We would like to thank the reviewers for their thorough reviews and constructive comments on the manuscript. The original comments are shown in regular black font. The responses to reviewer comments are shown in blue font, with text describing proposed additions and revisions of the manuscript shown in red font. Any original manuscript text is shown in gray font.

Reply on Reviewer #2

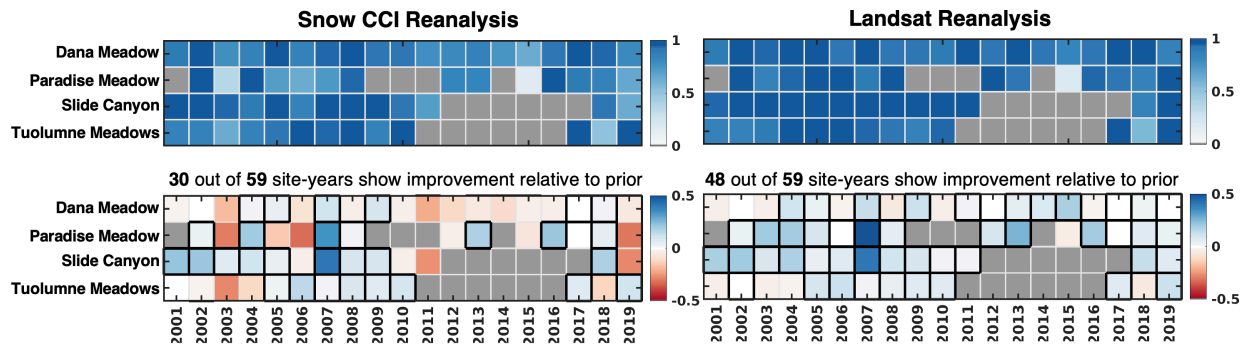
2. I have concerns about interpretations of differences in R correlation, particularly in Figures 7. A positive difference does not definitively mean that the correlation has improved, because R ranges from -1 to +1. For instance, a difference of +0.5 is not meaningful if the two R values are 0.0 and -0.5, as this indicates going from a weak negative relationship to no relationship at all. Hence, a positive difference in R is only a valid indicator of improved correlations when both are greater than 0. Why not just use R^2 here to avoid any of this potential ambiguity?

Response: Thank you for your comment. We've plotted the temporal correlation using R^2 , and the results remain consistent with the original analysis. We propose to replace the original figures with those below based on your suggestion.

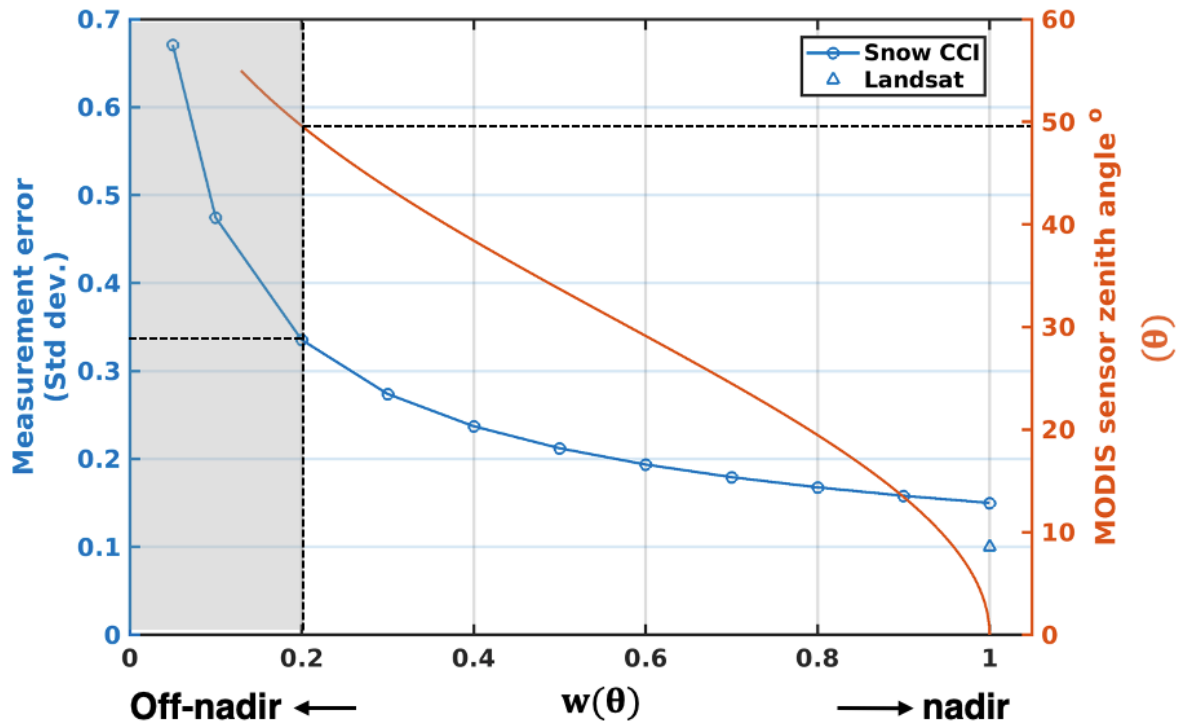
L.214-220 and Figure 3: What is theta angle for $w(\theta) \sim 0.2$? It might help to add a second (non-linear) x-axis with the theta values, as this might be easier for some to interpret (i.e., satellite view angle).

L. 245: Again, it is hard for a reader to know what theta angle corresponds to weights of 0.2 or less. Describing in terms of theta is more straightforward, in my opinion.

Response: Thank you for your suggestion. We propose to add a second y-axis with the theta values. The theta angle for $w(\theta) \sim 0.2$ is around 50 degrees.

Response: We propose adjusting Figure 3 (see above) to address this concern.

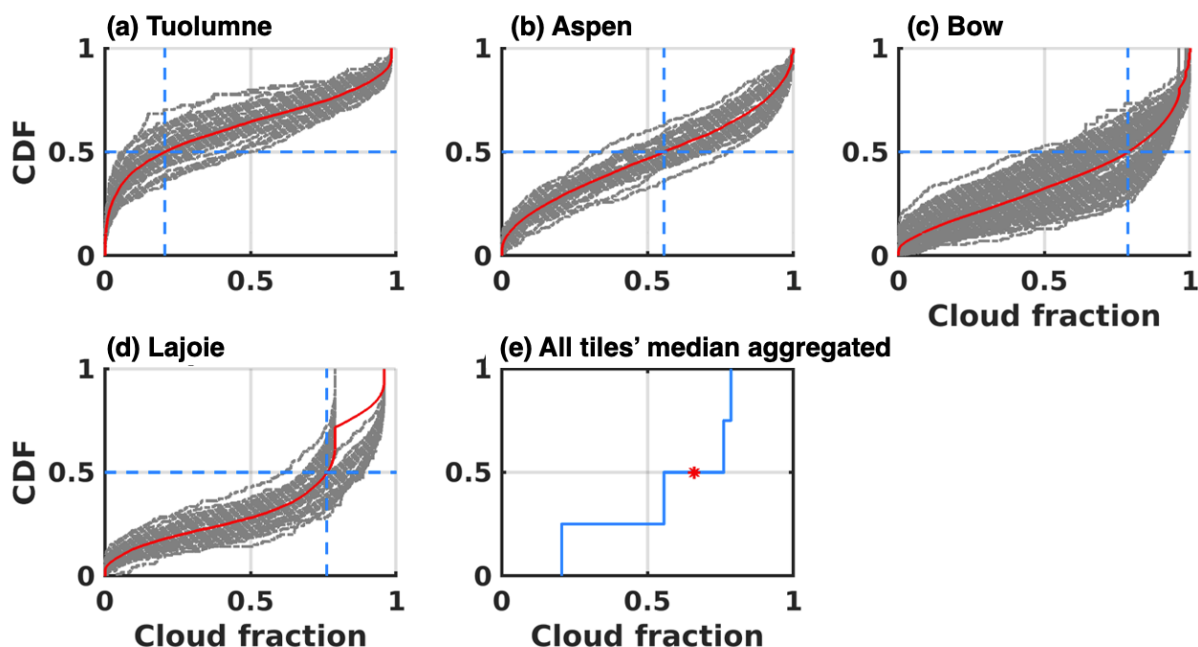
Figure 2: Why use the full water year for these distributions? I am not sure why summer (i.e., snow-free months) are relevant, especially given that Aspen may have cloudier summers than the other locations due to regular convective thunderstorms that occur over the Rockies. How would this figure (and thresholds) change if October-June was used instead of the full WY?

Response: Thank you for your comments. The attached figure shows the cloud threshold if October-June is used instead of full WY. The cloud threshold is about 0.66, which is similar (slightly higher) than the previously used threshold (0.6). Some implications of using different cloud thresholds are: using higher cloud thresholds result in eliminating more images, although certain pixels remain valuable. Otherwise, using lower cloud thresholds could result in including more cloudy images that likely misclassify snow as cloud.

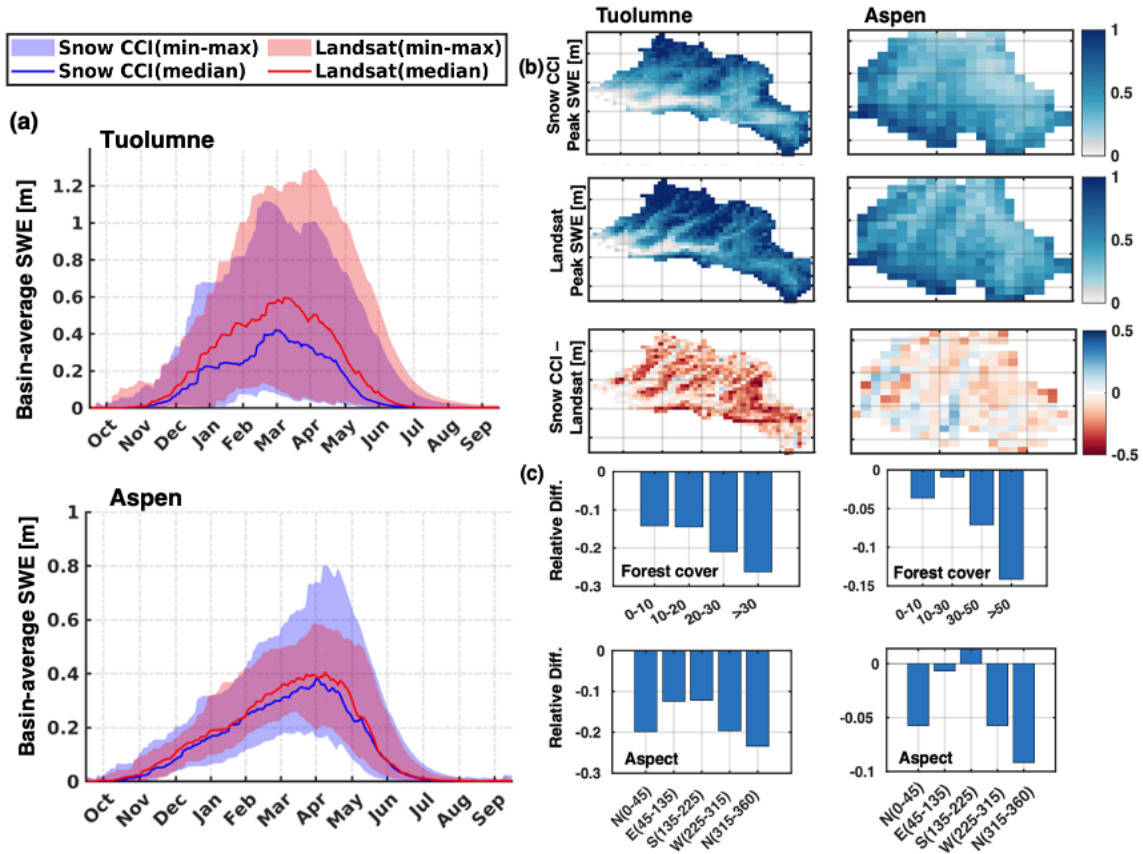
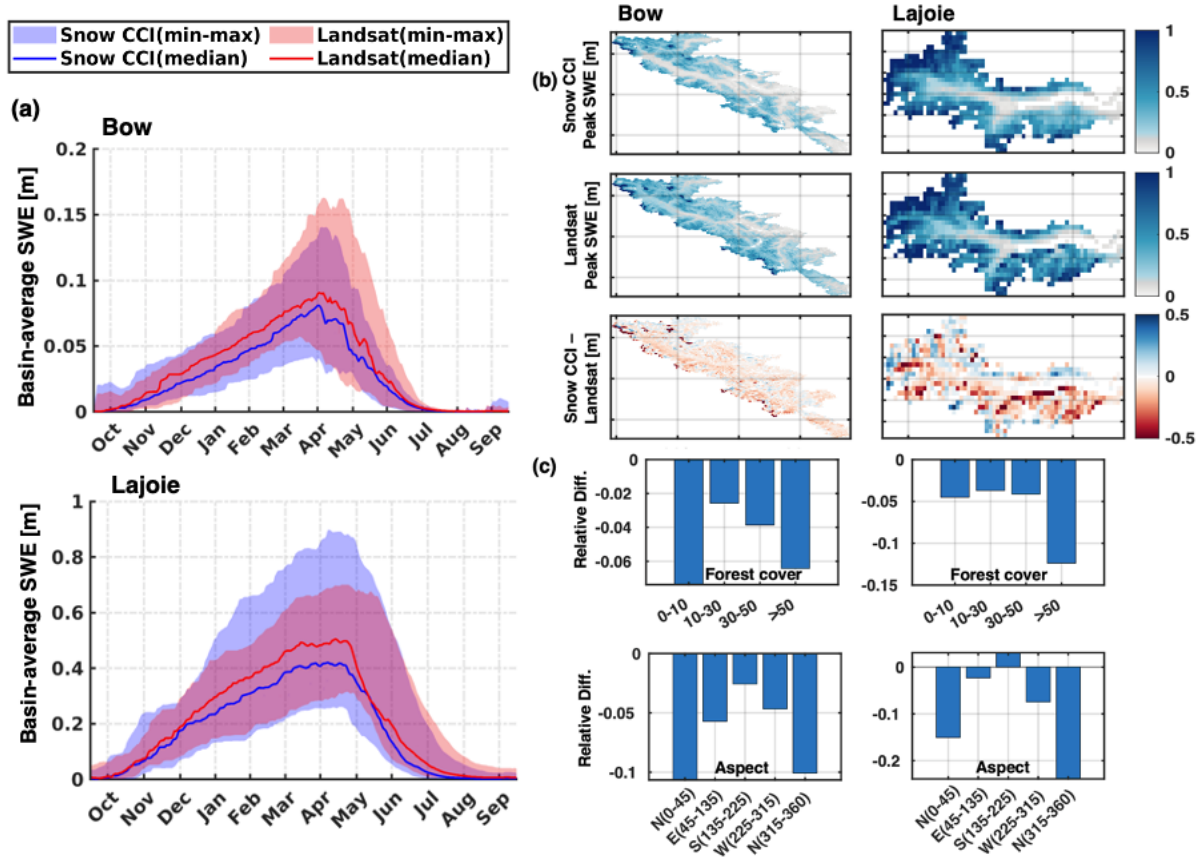
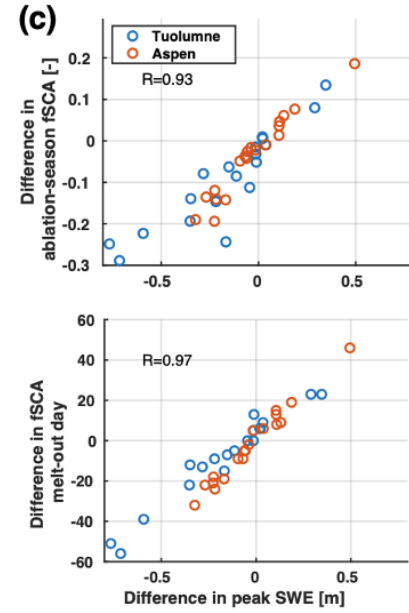
Figures 9 and 14: I have trouble interpreting the stacked shading here. Is there a better way to convey the ranges?

Response: We explored alternative ways to represent variability, such as using the full range (minimum – maximum) instead of 1-99th percentiles.

We propose to revise Figure 9 to:

Similarly, we propose to revise Figure 14 to:

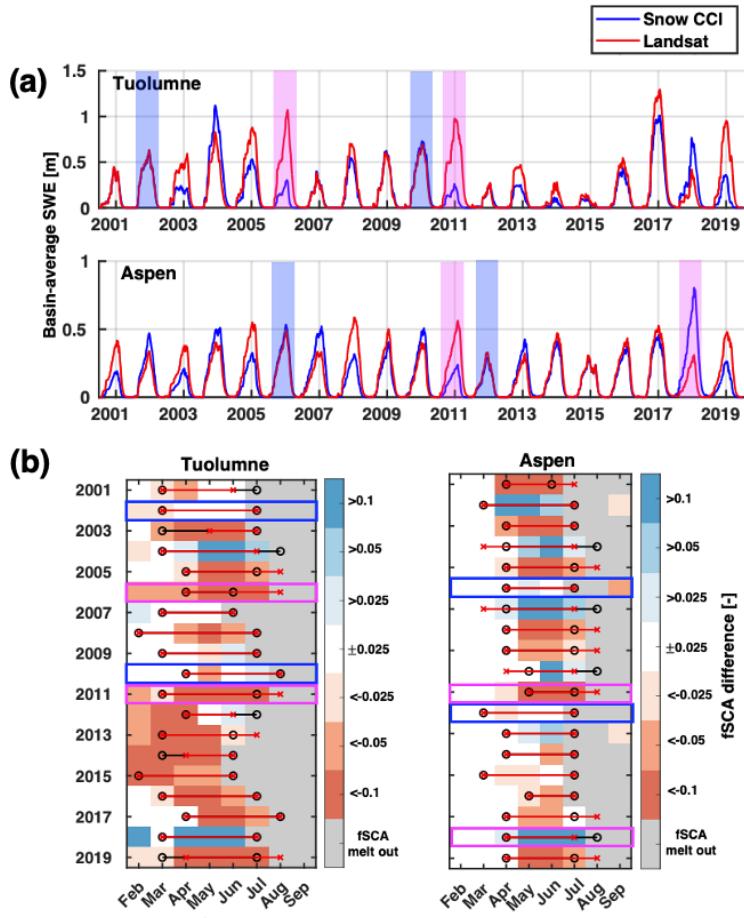
Figure 10: Looking at this figure and caption alone, it is impossible to discern what the blue and magenta shading represents. This comes later in Figure 11. Need to include the information in both places so your readers can understand.

Figure 10c: Suggest stacking these two panels vertically rather than horizontally so their common axis (Difference in peak SWE) is shared/aligned.

Response: We propose to add a description in the caption: Cases of consistent performance vs. inconsistent performance are highlighted in blue and magenta, respectively.

Response: Suggestion adopted. We propose to revise Figure 10 to:
